SUBJECT: SUMMARY OF MEETING HELD WITH JERSEY CENTRAL POWER &
LIGHT COMPANY (JCP&L) TO DISCUSS HIGH ENERGY LINE
BREAKS INSIDE CONTAINMENT (SEP TOPIC III-5.A.)

OYSTER CREEK NUCLEAR GENERATING STATION UNIT 1

SEP TOPIC III-5.A
HIGH ENERGY PIPE BREAKS INSIDE CONTAINMENT

RX CLEAN UP SYSTEM

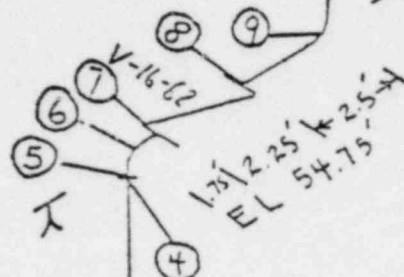
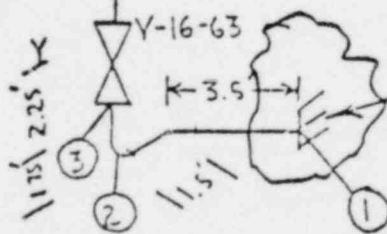
- (2) Figure B-8 shows 11 break locations while Table 8 includes four break locations. Break locations 2, 3, 4, 7, 8, 9 and 10 did not appear in the table. These break locations were deleted based on the revised seismic analyses, as documented in the submittal of February 6, 1979, Page 5. Accordingly, while these break locations were included in the original interaction evaluation, they were not included in any subsequent evaluations.

1. Cleanup return line, 6-inch ND-10, Isometric Figure B-8, break point number 1 (a Category 3 break*).
2. Emergency condenser, 10-inch NE-2 from NE01-B, Isometric Figure B-3, break point number 1 (a Category 2 break).
3. Feedwater south, 10-inch RF-2, Isometric Figure B-12, break point number 2 (a Category 2 break).
4. Recirculation loop B, 25-inch, Isometric Figure B-15, break point number 1 (a Category 2 break).
5. Core spray south, 8-inch NZ-3, Isometric Figure B-5, break point number 1 (a Category 1 break).

A circumferential break at point 1 will not result in an interaction with any of the listed targets.

A circumferential break at either point 2 or 3 will most likely cause the pipe to whip about a hinge formed at the connection to the recirculation piping in such a manner as to result in no interactions.

A circumferential break at point 4 or 5 will most likely place the connection to the recirculation piping in torsion causing the pipe to whip in such a manner as to result in an acceptable interaction with 8" NQ-2 at elevation 37', azimuth 25° of Sheet 3 (3). Such a break could also cause the pipe to whip about a hinge formed at the connection to the recirculation piping which would result in an unacceptable interaction with the containment vessel at elevation 51', azimuth 65° of Sheet 4 (3).

A circumferential break at point 6 or 7 will most likely place the connection to the recirculation piping in torsion causing the pipe to whip in such a manner as to result in an acceptable interaction with 8" NQ-2 at elevation 37', azimuth 25° of Sheet 3 (3). Such a break could also cause the pipe to whip about a hinge formed at the connection to the recirculation piping which would have the same result.

A circumferential break at points 8 thru 11 will not result in pipe whip as check valve V-16-62 isolates these points from the energy reservoir (reactor).

A break at point 1, 2, or 3 will result in an unacceptable jet impingement interaction with the cable tray at 40', azimuth 80°-90° of Sheet 3⁽³⁾. A break at any of the remaining points postulated in this line will not result in any jet impingement interactions with the cable tray or any of the motor operators.
